Before the Board of Inquiry
Waterview Connection Project

Rebuttal evidence of **Gavin Fisher (Air Quality)** on behalf of the
NZ Transport Agency

Dated: 3 February 2011

Raising the vent height

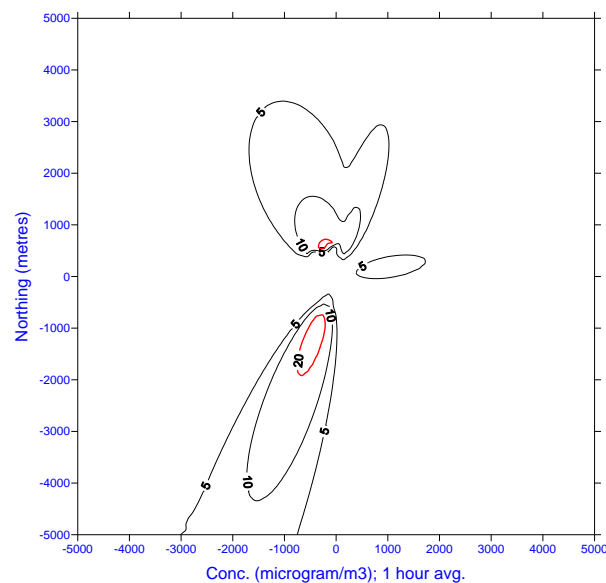
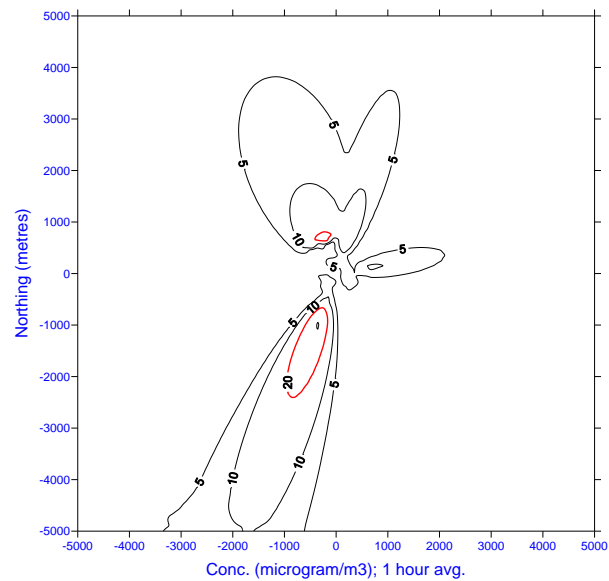
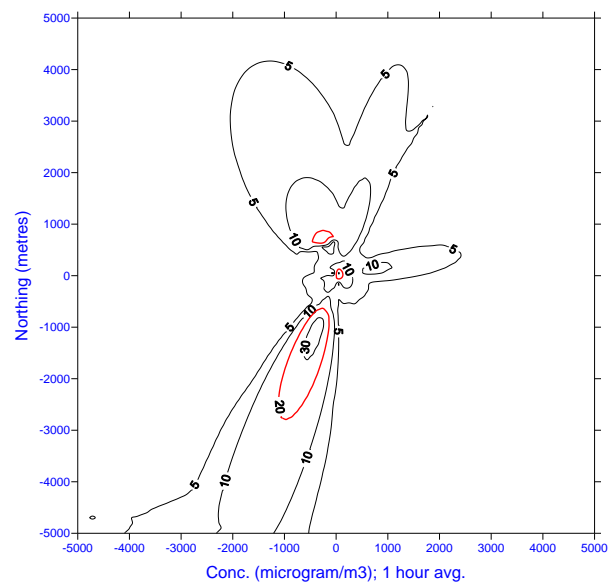
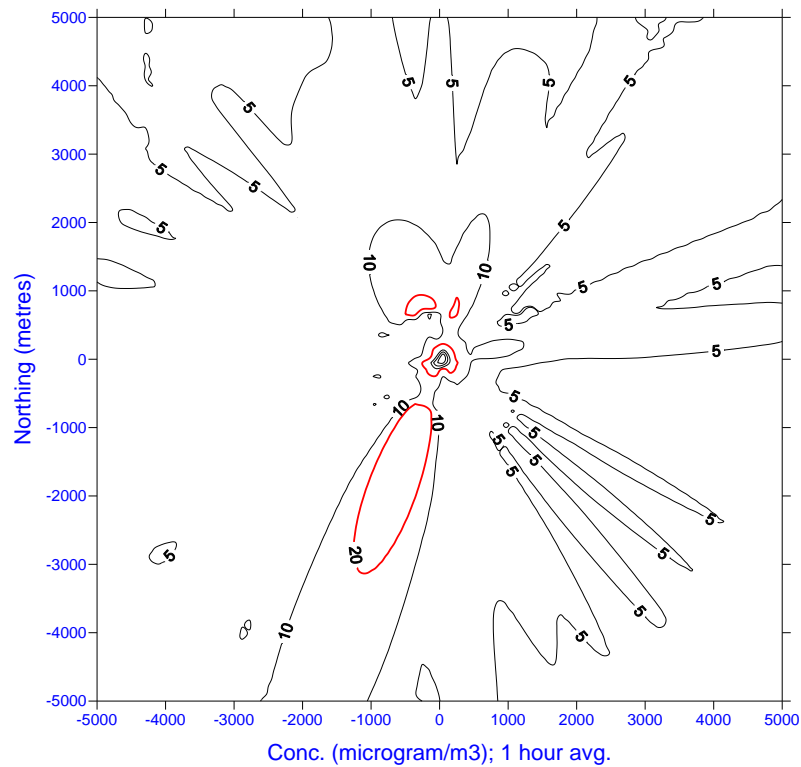
- 25 **Vent Heights:**²⁰ For visual amenity reasons, it has been suggested that the vent heights be reduced from 25m to 15m. From an air quality perspective, higher stacks are better. However, a 15m is adequate to avoid any significant adverse air quality effects.

- 26 A modelling analysis for different stack heights was conducted very early and given in the original assessment²¹. Based on this a vent height of 25m was determined. However more recently, and particularly as a result of the expert caucusing on 18 January 2011, it became necessary to re-evaluate the effects from a lower vent (15m). The Council, at expert caucusing, would only agree to this if a new modelling run could show the effects were acceptable to it.²² A full featured Calpuff modelling run for this case of varying vent heights has not been able to be completed as the model is very complex and takes several weeks to run. It is expected on or about 10 February. However a simplified and more rapid modelling exercise has been undertaken, summarised in **Annexure B**.

- 27 This shows that although ground level concentrations due to the vent emissions do go up slightly (a few percent at distances greater than 50m from the vents, and perhaps 50% closer than 50m) with a lower 15m height, they are still very small, and do not result in any exceedences of relevant standards or guidelines at any location.

50m: Going from 25m to 50m makes only a little difference. Effects are slightly less, especially closer to the vent (0-200m). Concentrations further out are not affected as much, as these are more dominated by larger scale weather features. (At a 100m vent height, the results start to become significantly lower, but this is certainly not a viable option).

15m: Going from 25m to 15m also makes only a small difference in the bigger picture, however peak 1-hour NO_x concentrations very close to the vent (<50m) could go up from around 30 to 130 $\mu\text{g m}^{-3}$.

5m: Going down to 5m also makes very little difference in the surrounding terrain. It does have a difference very near (<50m) where the concentrations do increase, but even at this height the peak 1-hour NO_x concentration at the first grid point (50m) is still only 132 $\mu\text{g m}^{-3}$. This might still be “acceptable” when added to the background of 65 $\mu\text{g m}^{-3}$, and allowing for a realistic conversion rate.

ANNEXURE C ANALYSIS OF SEPARATION DISTANCE

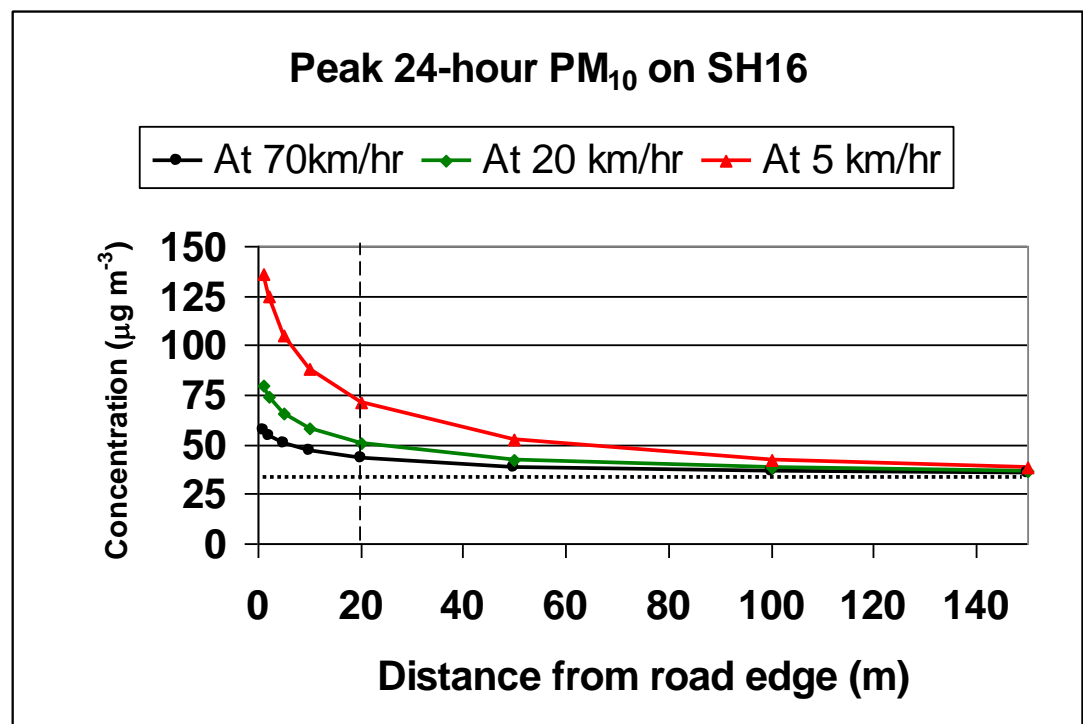
- 30 **Concrete batching plants**²⁵: It is now confirmed that the concrete batching plants and conveyers will be fully enclosed.
- 31 **Separation distances**²⁶: One of the principal concerns expressed in the Air Quality s42A Report (and previously in the Auckland Council submissions and evidence) was the final separation distances between some residences and the new road route. This is a very site specific factor that depends on local conditions. In my view a separation of 20m is adequate.

- 32 In support of this view a further modelling analysis has been undertaken to show effects at places very close to the busiest portions of the road. These are on SH16, and the summary results shown in Table 1 below are based on the 2016 year (the 2026 year results are lower), and assuming a maximum daily traffic flow of 135,000, a flow speed of 70 km/hr, and a maximum hourly flow of 10,000. A more detailed result is shown in a separate modelling exercise in **Annexure C**.

This shows that for SH16, at full capacity, the separation of 20m from the road edge provides enough of a buffer under the most common circumstance of freeflow traffic, as well as under moderately congested conditions. It may not under highly congested conditions, but it is doubtful that such conditions as these will ever occur (135,000 vehicles using the motorway going 5 km/hr over 24-hours).

Figure 1. Southern portal NO_x discharge concentrations (ppb) and maximum 1-hour NO_x concentrations (µg/m³) predicted at the most affected residential property with respect to traffic volume for the 2016 emission conditions

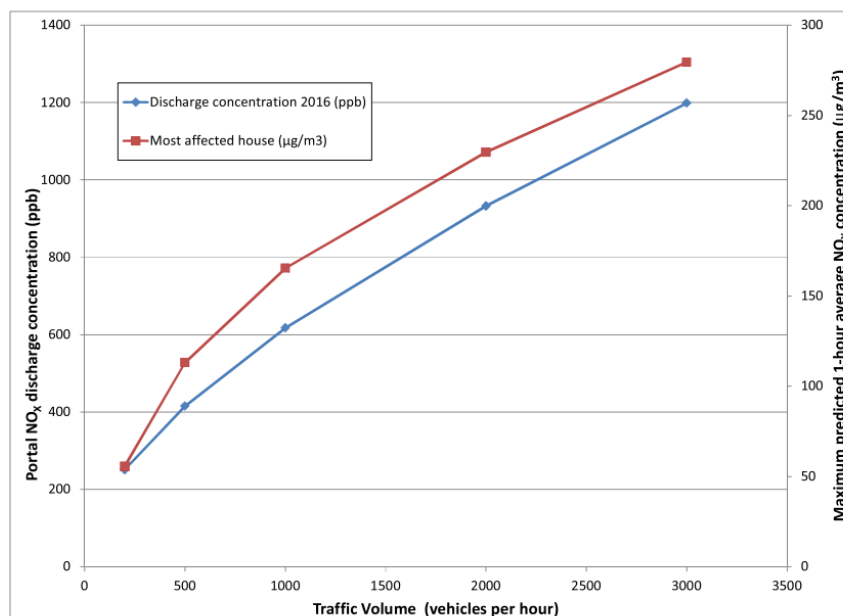
- 49 An additional modelling analysis has been undertaken on the effects of portal emissions with the fans turned down. This is summarised in **Annexure D**.

- 50 These new results show that the operation of the tunnel without the ventilation fans running will not result in any adverse effects, indicated by NO₂ exceedences at a location equivalent to the nearest house (50m from the southern portal), for almost all circumstances when the traffic in the tunnel is less than 1000 vehicles per hour.

This plot shows the expected worst case effects of portal emissions in the event the fans are off, for various levels of traffic flow (note that the peak rate is 3,700 vehicles per hour, but there will never be a circumstance when the fans would be off at this peak rate – or even close to it).
